Service-Information

Group 11 Engine	May 1983	Bulletin No.: 11 024 83 (2077)
--------------------	-------------	-----------------------------------

RE: INSTALLATION OF THE OIL FILTER HOUSING CANISTER

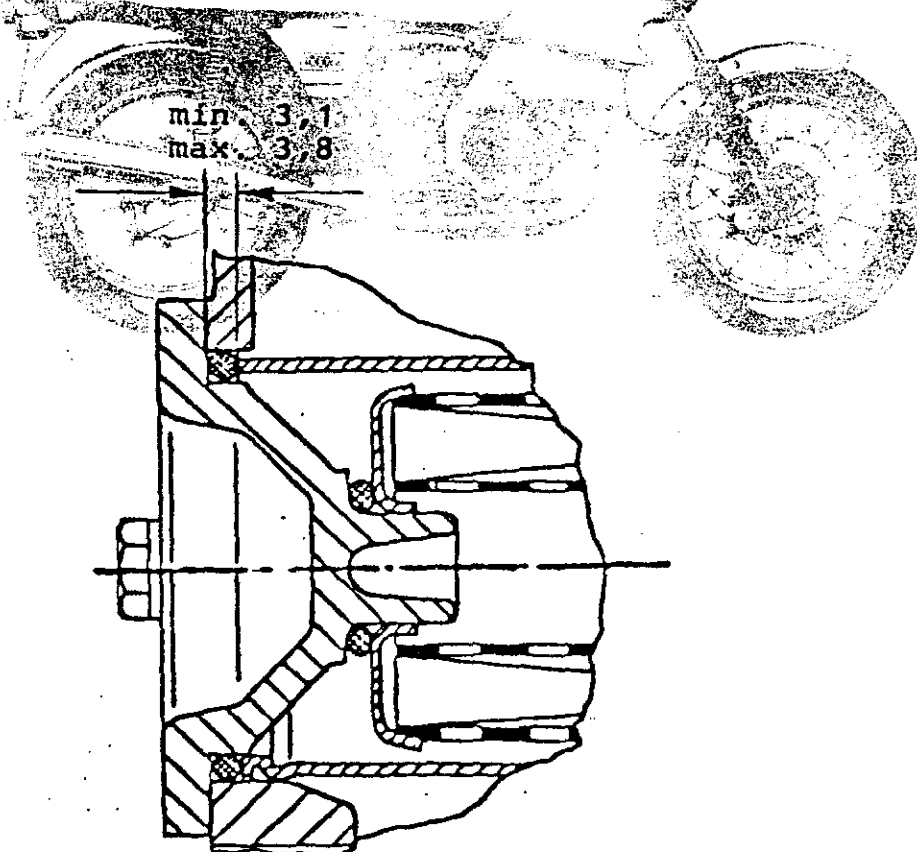
We suggest that during any service or rebuilds, the depth of the oil filter canister sleeve to crankcase cover be measured:

The distance between the oil filter cover surface and the face of the oil filter canister sleeve should be as referenced in the line drawing. Excessive clearance will cause a poor seal between the cover and canister sleeve and oil pressure will be reduced or fail.
